Memorandum to the City of Markham Committee of Adjustment

File: A/061/21
Address: 44 Sir Bodwin Place – Markham, ON
Applicant: Ishaan Arora
Agent: Mark Coroza
Hearing Date: July 21, 2021

EXISTING & PROPOSED
FRONT ELEVATION

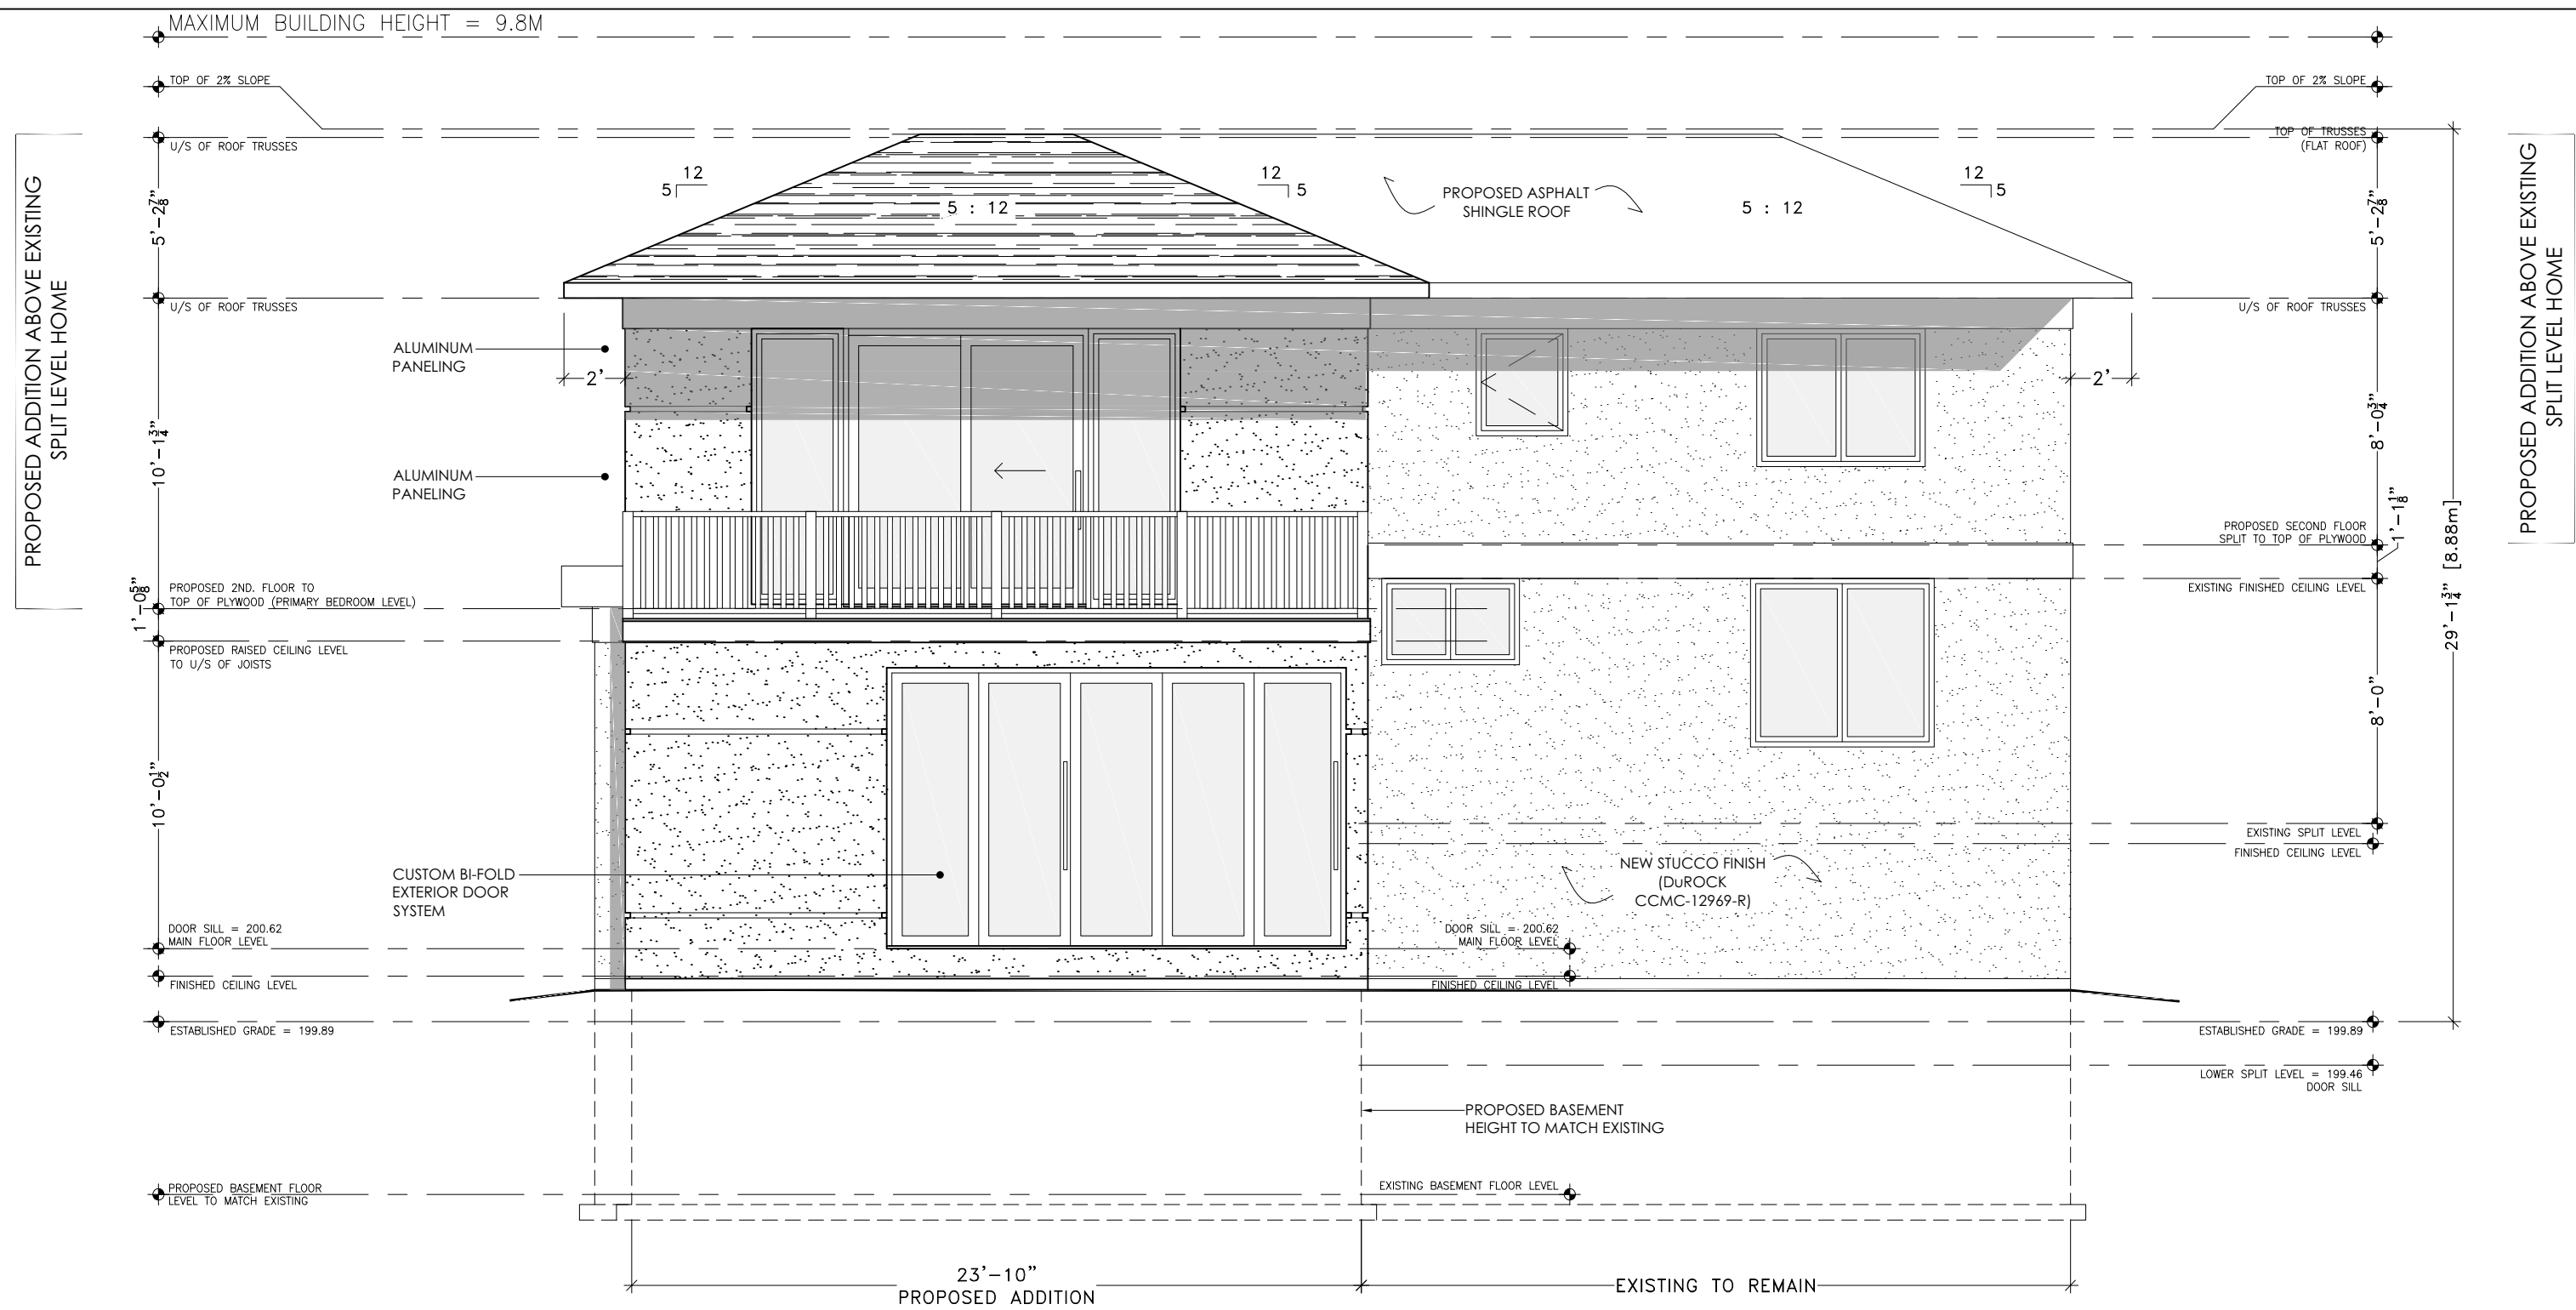
It should be noted that when viewed from the street, the placement of windows assist in the integration of a concealed third-storey that could be comparable to, and consistent with a two-storey dwelling with greater floor heights, and the height requirements of the By-law.
